Product Update

New appearance of Modular contactors (GC / GY range)

> August 2013

Design and dimensional changes

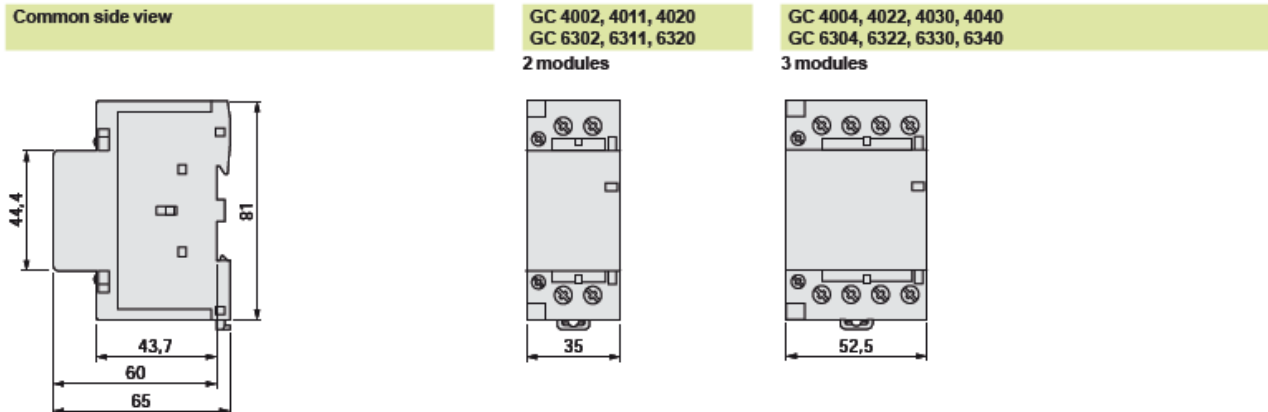
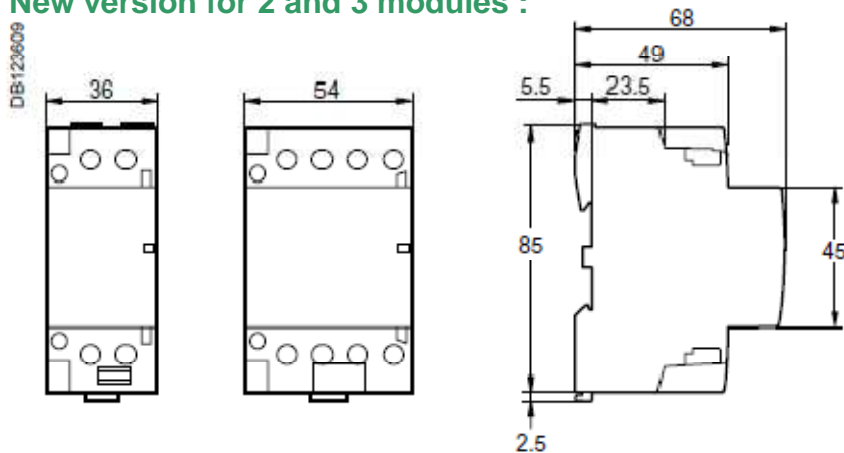
- 1 module (17,5mm)** : 16A and 25A 1P and 2P : **No modification**
- 2 modules (35mm)** : for 16A/25A : 3P and 4P and for 40A/63A : 1P et 2P
- 3 modules (52,5mm)** : for 40A/63A : 3P and 4P

Old version for 2 and 3 modules :

New version for 2 and 3 modules :

Design and dimensional changes - Continued

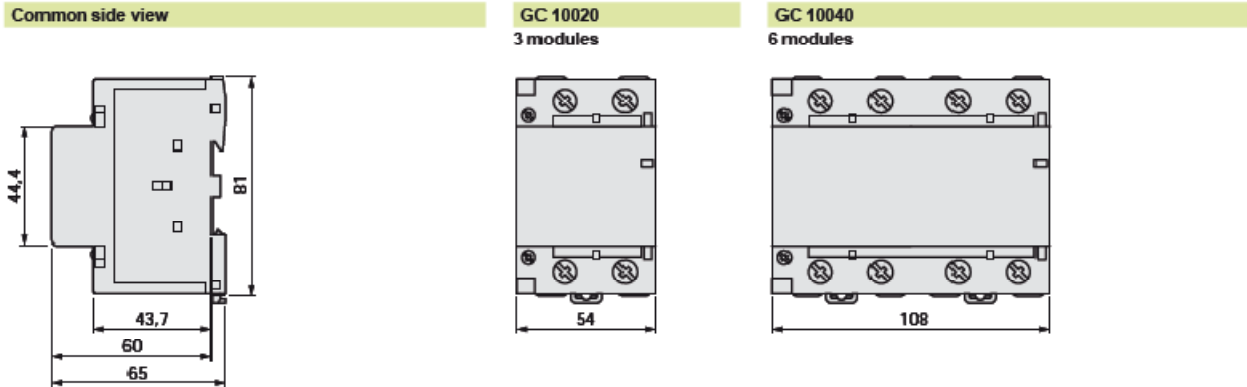
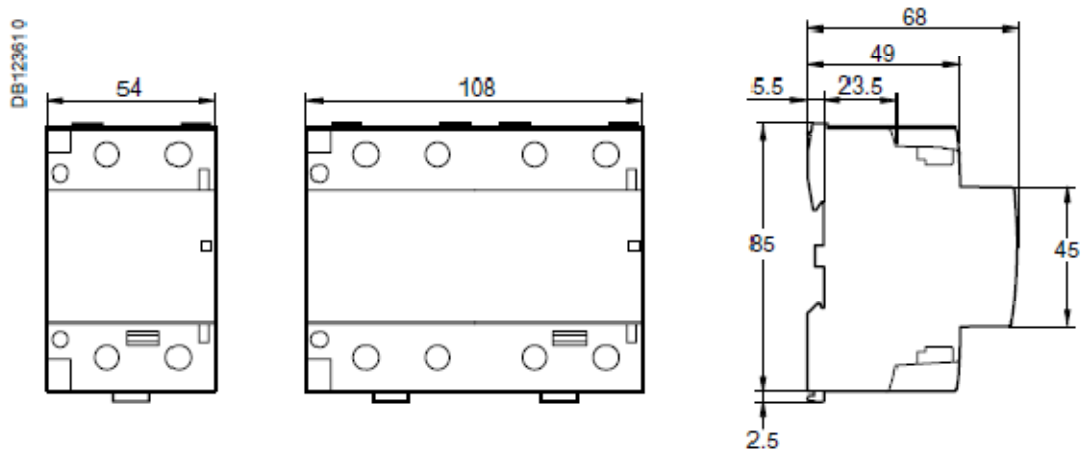
3 modules (54mm) : for 100A : 2P

6 modules (108mm) : for 100A 4P

Old version for 3 and 6 modules :

New version for 3 and 6 modules :
